VILLAGE OF THIENSVILLE
Plan Commission
AGENDA

DATE: Tuesday, March 12, 2024

BACKYARD SHED 304 WOODSIDE LANE

KLUG REPLACEMENT GARAGE

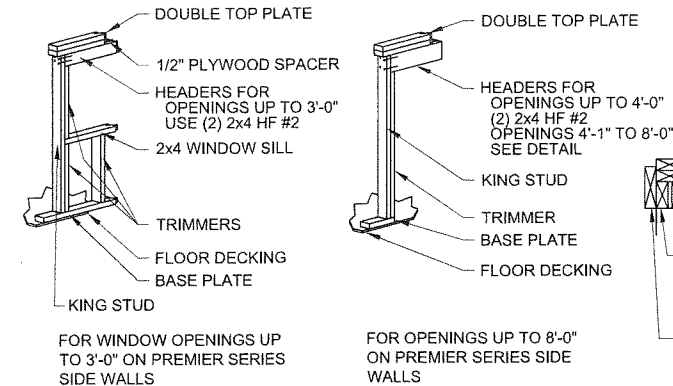
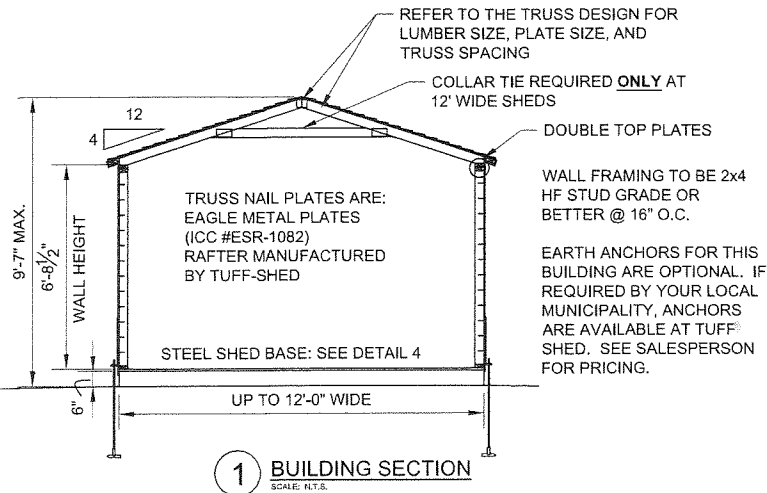
The applicant is requesting to replace the existing 7' x 7' backyard shed with a new 8' x 12' shed that will be set back 41' from the back of the house, 16' from the north property line and 21' from the east line. The shed will have a double door entrance on the front and will be tan with white trim to match the color of the house.

According to **Sections 17.0603. E.** of the zoning code, **Accessory structures, such as garden or utility sheds, shall be placed or erected in the rear yard provided, cannot exceed 150 square feet and shall not be closer than 5 feet to the principal structure, shall not exceed 12 feet in height and shall be located no closer than 3 feet to any property line.**

Staff's review indicates full compliance with the R-1 requirements that therefore approval is recommended subject to the following:

- The applicant secures a building permit prior to construction.

GRACE 242 - CHANNEL LETTERS ON RACEWAY - FACE LIT - PROOF 1

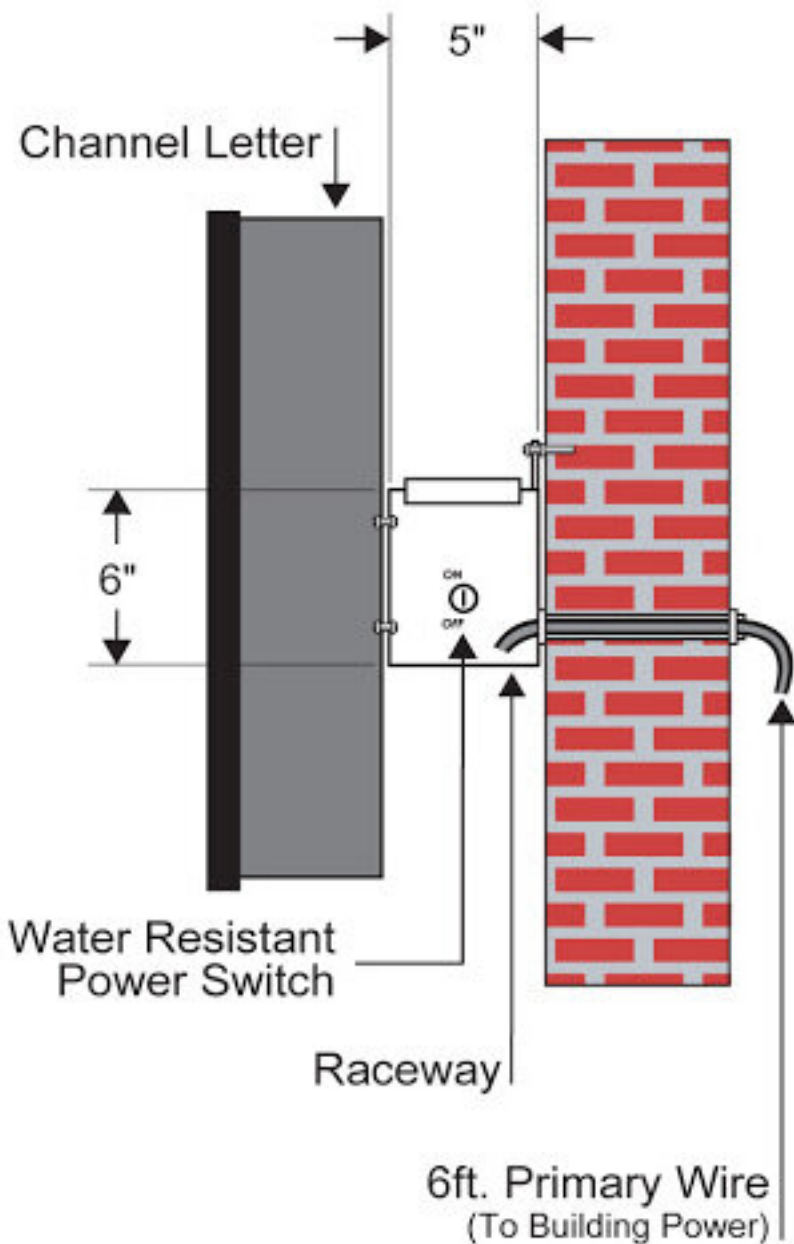
The applicant is requesting approval of a wall mounted sign to be located within the shopping center at the corner of Freistadt Road and Main Street at 249 N. Main Street. The proposed sign measures 7.9' long by 1' tall for eight square feet in size. The sign will be interior lit with red letters and black numbers consistent with style of other signs within this shopping center.

This sign is compliant with intent of the code where **Section 16.17 1. I.e.** states: **Internally lit signs shall be constructed with an opaque surface to allow internal light to only project through the cut-out lettering and/or logos. Dark colored backgrounds on signs are generally encouraged. Stark white or extremely bright background colors are discouraged.**

Staff recommends approval of the wall mounted sign as proposed subject to the applicant securing a sign permit prior to installation,

Survey with new Garage

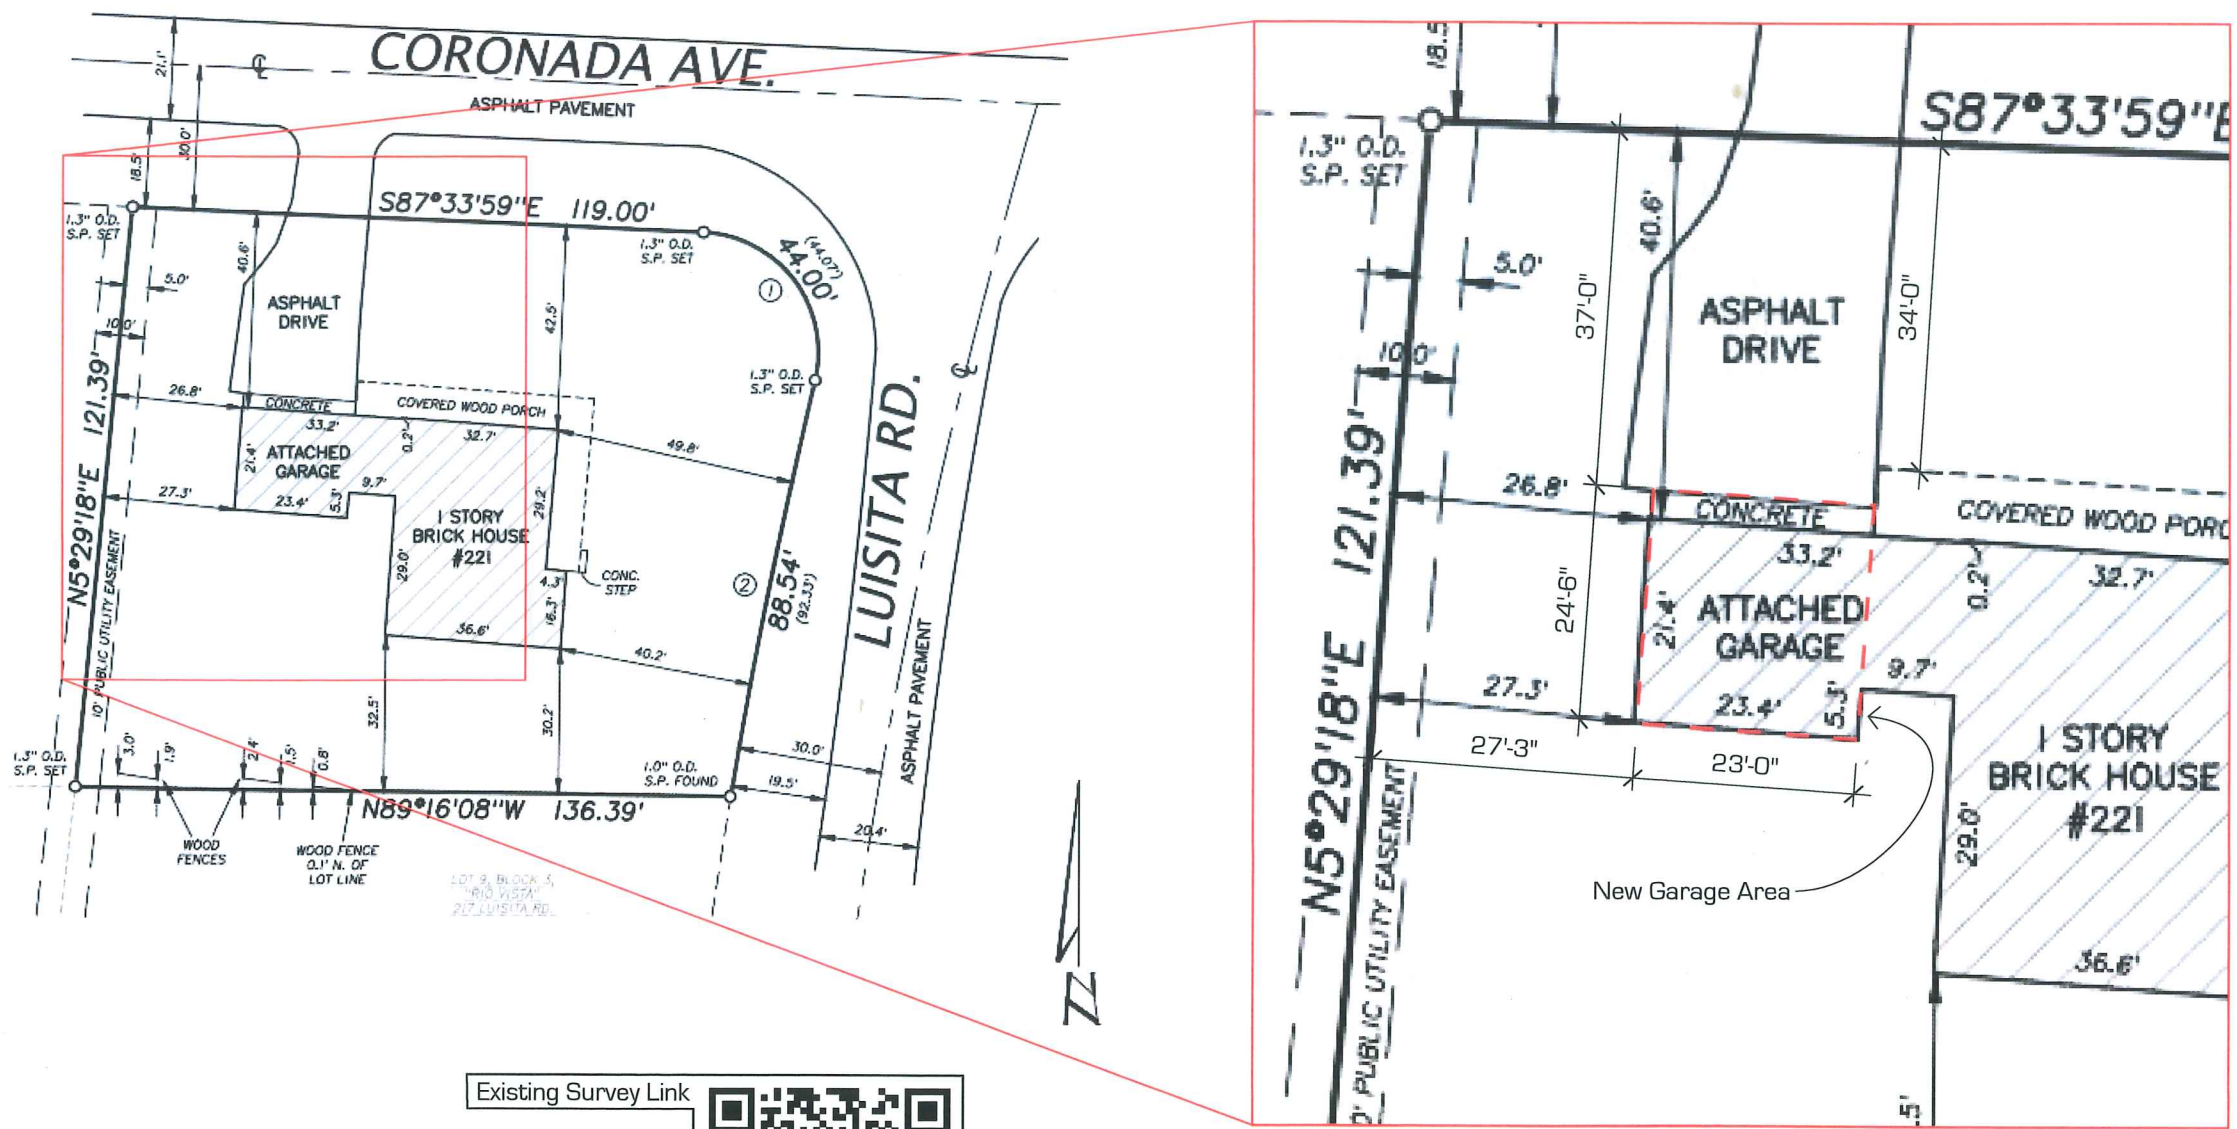
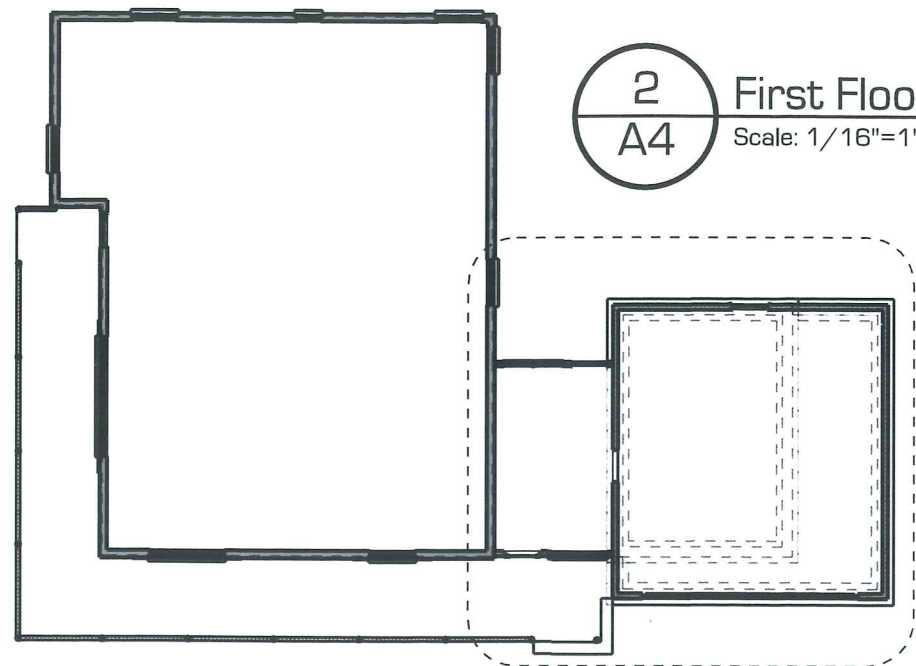
The applicant is proposing to remove the existing attached garage and breezeway and replace it with a two-car garage for the home located at 221 Luisita Road. The replacement garage will stand approximately 12” higher than the existing to accommodate the new standard garage door. The applicant’s plans indicate that the new garage materials and color scheme will match those of the home. Staff’s review indicates that the proposed garage meets the requirements of Section 17.0303 F.(2) of the Zoning Code, which requires a minimum side yard of 10 feet and a front yard setback of 40 feet. Therefore, the proposed garage is code compliant.

Since the plans are code compliant with the R-1 District requirements approval is recommended subject to:

- The applicant secures a building permit prior to construction.
